ICHD - ENVIRONMENTAL HEALTH DIVISION

SEPTIC: IMPROVEMENT PERMIT / AUTHORIZATION TO CONSTRUCT / OPERATION PERMIT / EXISTING SYSTEM

SITE ADDRESS: 116 CHURCHILL LANE, MOORESVILLE, N.C. 28117 | PHONE: 704-202-9214 | ALT. PHONE 704-200-4291

Re: Basement Wall Evaluation
116 Churchill Lane
Mooresville, NC

AS BUILT SKETCH

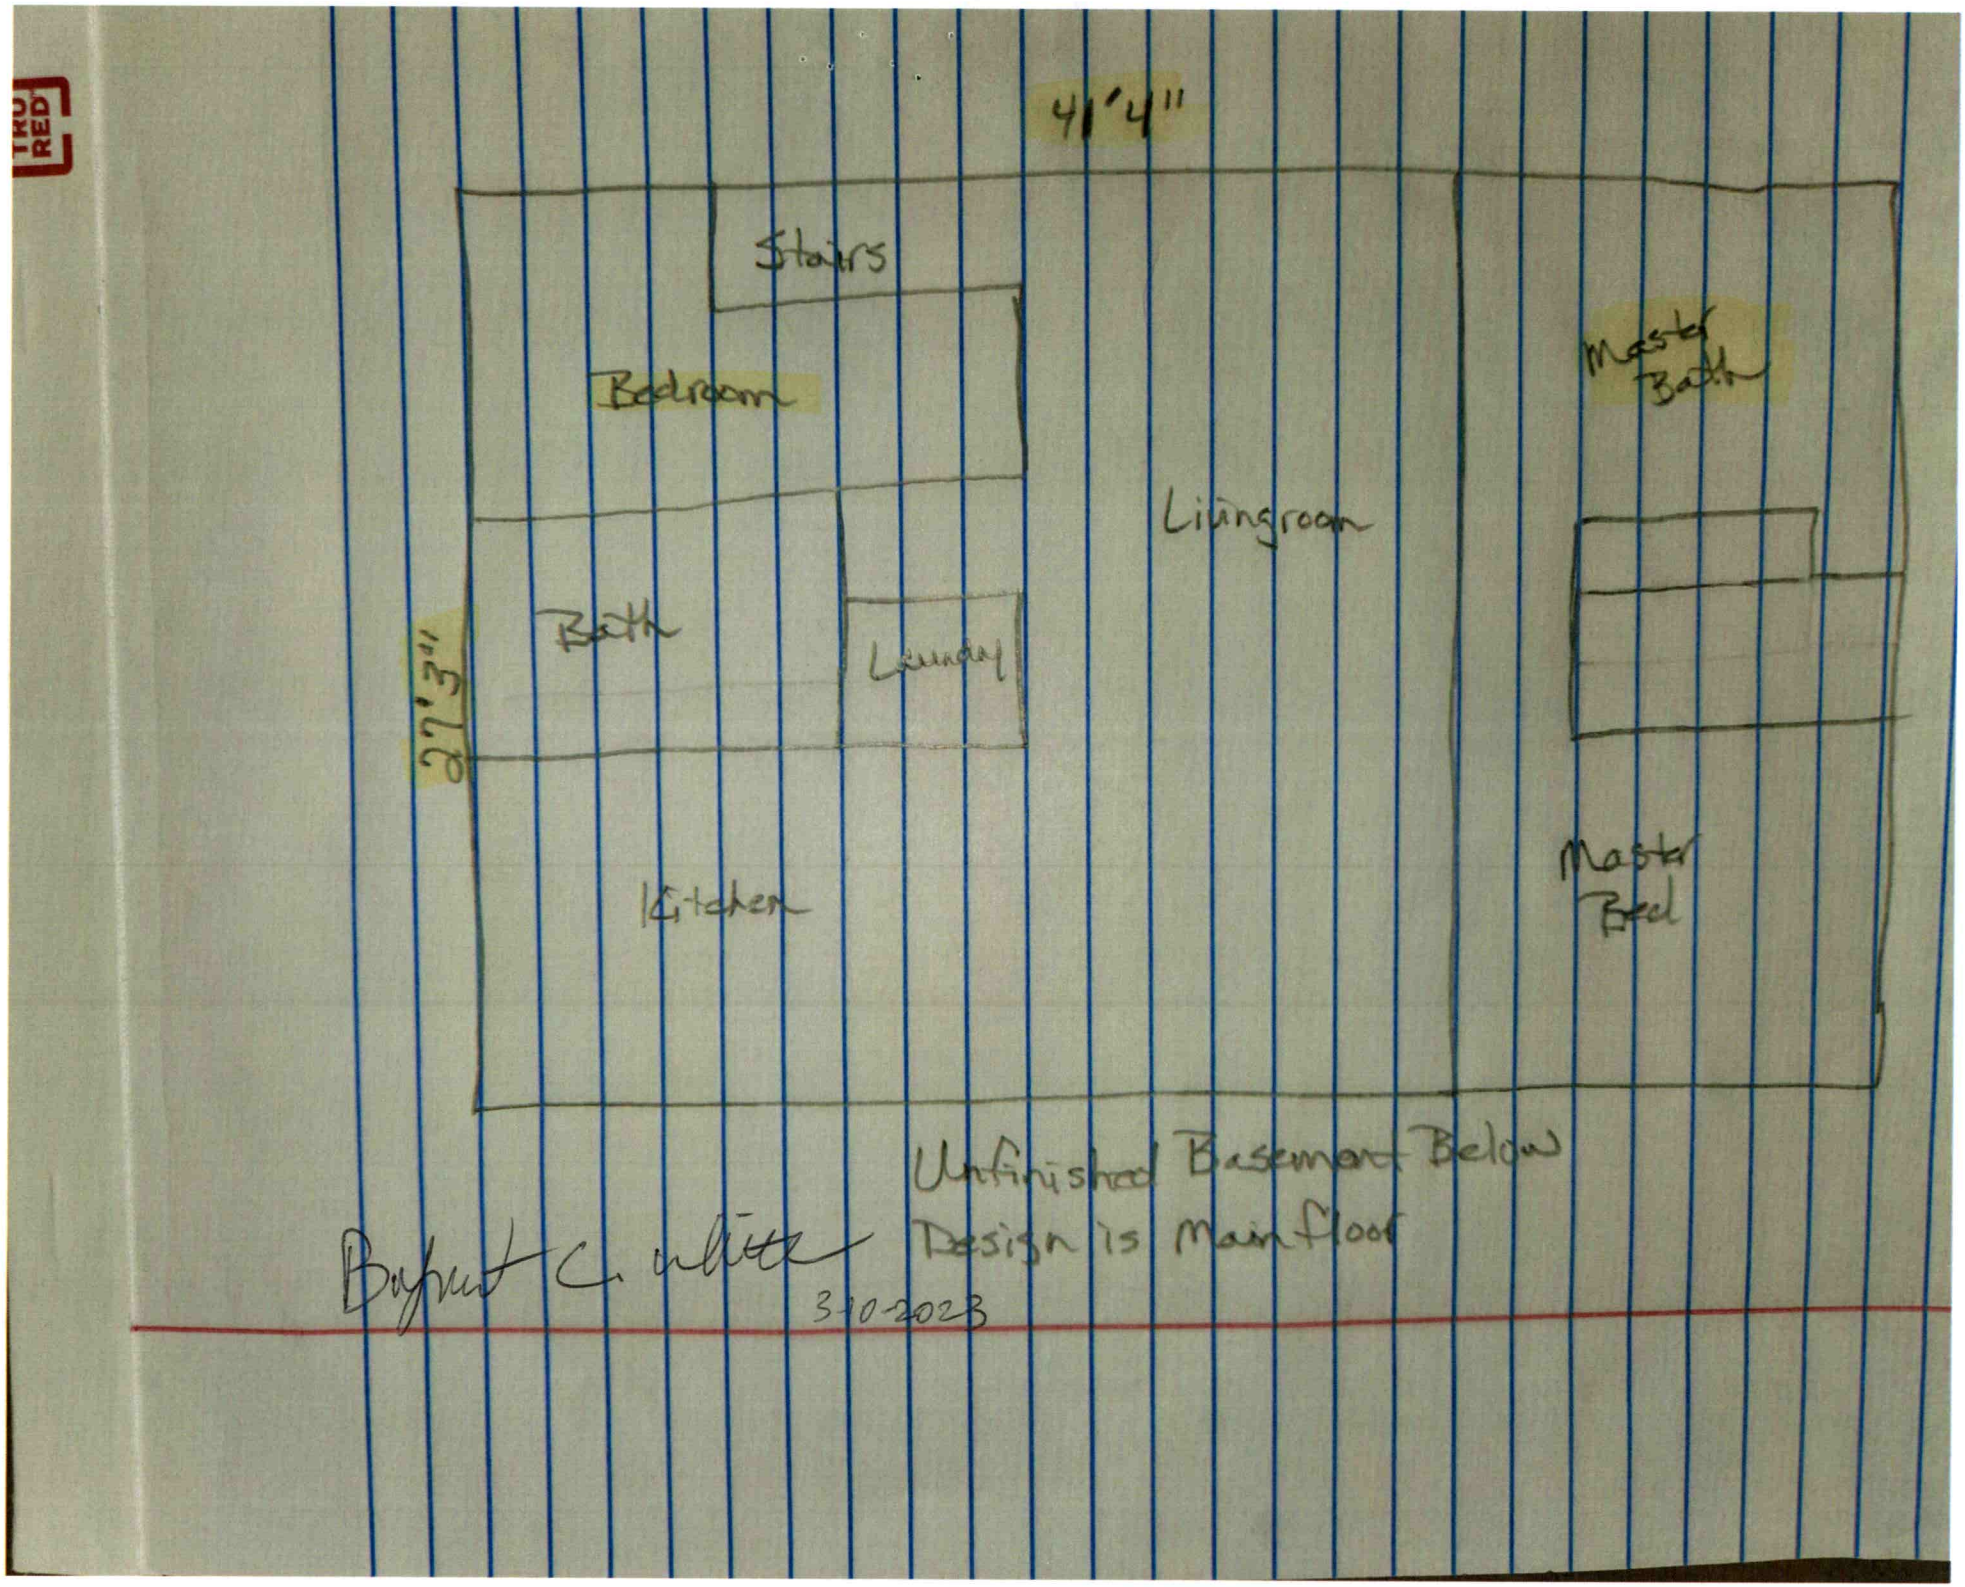
Comments / Conditions: SYSTEM APPEARED TO BE FUNCTIONING AT TIME OF INSPECTION, SYSTEM IS IN 50FT BUFFER, SEE PREVIOUS 3BR PERMIT BY DAVID HINSON IN 1983

ANCHOR BOLT DETAIL

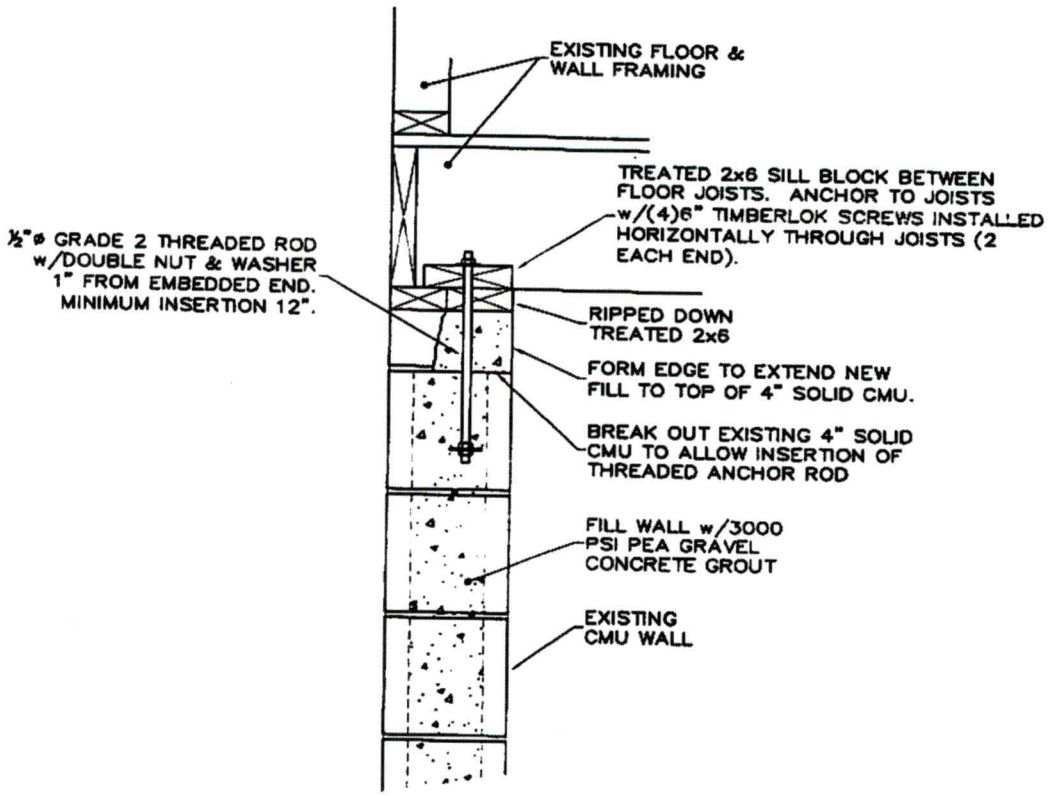
Specifically, the home is a one story wood frame unfinished structure with a full walkout out basement which began construction in 1983. The 8'-4" tall foundation/basement wall is an un-reinforced 12" CMU structure that transitions to an 8" CMU just below the planned backfill height. The backfill height varies up to approximately 48". The original plan was to finish the exposed portions of the wall with 4" brick, though the new plan maybe for stone veneer. The wall was never backfilled to the planned height and grading around the perimeter still slopes toward the wall. There is a waterproofing coating visible just above the current backfill line. The left and right side walls support a steel beam embedded at the center (approx.) of the wall. The wall is capped with a course of 4" CMU.

The wall is generally in good condition. There were no visible cracks and the wall remains vertical and intact. There was however some water along the rear portion of the basement predominantly in the left rear corner where back fill as deepest at 48". The wall supports the first floor framing (which is also unfinished) on a 2x4 sill and is not anchored to the foundation wall. The size of the footing could not be determined though it is assumed to be independent from the floor slab as the CMU extends past the top of slab at the wall base.

I recommend excavating the exterior of the wall to allow for the waterproofing to be refreshed and a new current code compliant foundation drain to be installed. While the base of the wall is exposed, I recommend excavating the edge of the footing in several locations so that the size and condition of the footing can be estimated and evaluated. While the height of the backfill does not require that the wall be reinforced or filled with grout, the framing is required to be anchored to the wall. An anchor bolt detail is enclosed with this report that will provide for code compliant anchorage of the home. The CMU cells at the anchor bolt locations will require fill with 3000 psi grout at least 3 courses deep and in the cells on either side of the threaded rod. The cells under the centerline beam must also be filled.
